DAVIS-BESSE 1 RER DESIGN

7.6.1 (10/4/74)

DAVIS-BESSE NUCLEAR POWER STATION
DOSES VS. TIME
FIGURE P7.6.1-1

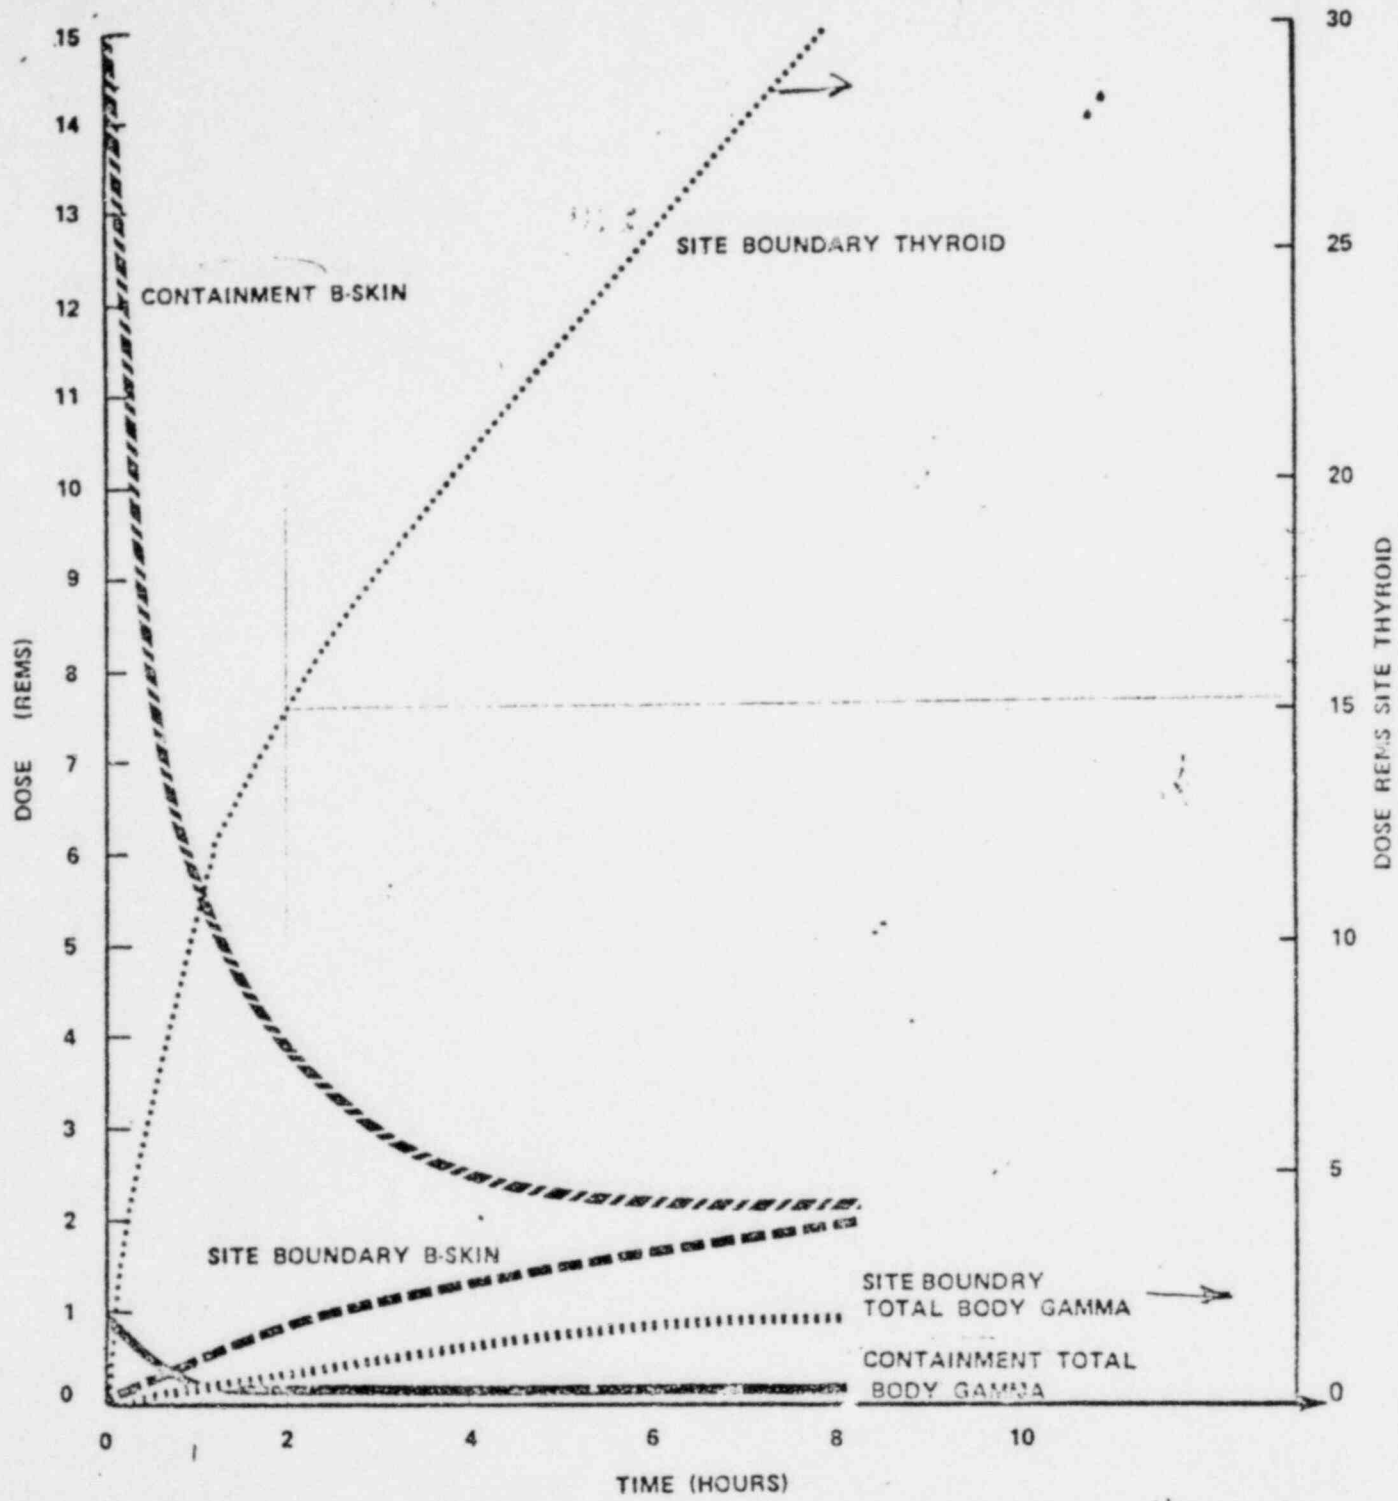
From our review of the Decay Heat Removal (DHR) System (Sections 7.6.1.1, 6.3.2.16, and Figure 6.17), we have concluded that this system is required for safety, i.e., to achieve cold shutdown of the plant. The present design does not meet the single failure criterion with respect to failure (to open) of either of two serially connected isolation valves (DH11 & DH12) in the suction line of the (DHR) pumps.

We will require that the (DHR) system design meet the single failure criterion from the standpoint of assuring decay heat removal (i.e., cold shutdown) and from the standpoint of precluding overpressurization of the system, and that the associated instrumentation, control and electrical systems conform with IEEE Std 279-1971 and IEEE Std 308-1971. Therefore, modify your design to meet these requirements, or justify the present design on some other defined basis.

System changes have been made. The manual bypass has been changed as follows:

1. The removable section of piping has been inserted permanently into the bypass.
2. Both valves on the bypass will be designed for primary system pressure and
3. The two "bypass" valves will be locked closed, with the necessary administrator controls.

Single failure of one of the motor-operated isolation valves could be accommodated by a member of the operations staff entering the containment after sufficient purging if deemed necessary, and open the manual bypass valves. The resultant dose to the man entering the containment is 0.23 rem. The site boundary doses are shown in figure P7.6.1-1.

Thyroid dose to the operator is reduced significantly by the use of the Scott air pack and in all cases is negligible compared to the gamma dose. If the man were to enter the containment without purging, the resultant gamma dose would be only 0.91 rems.
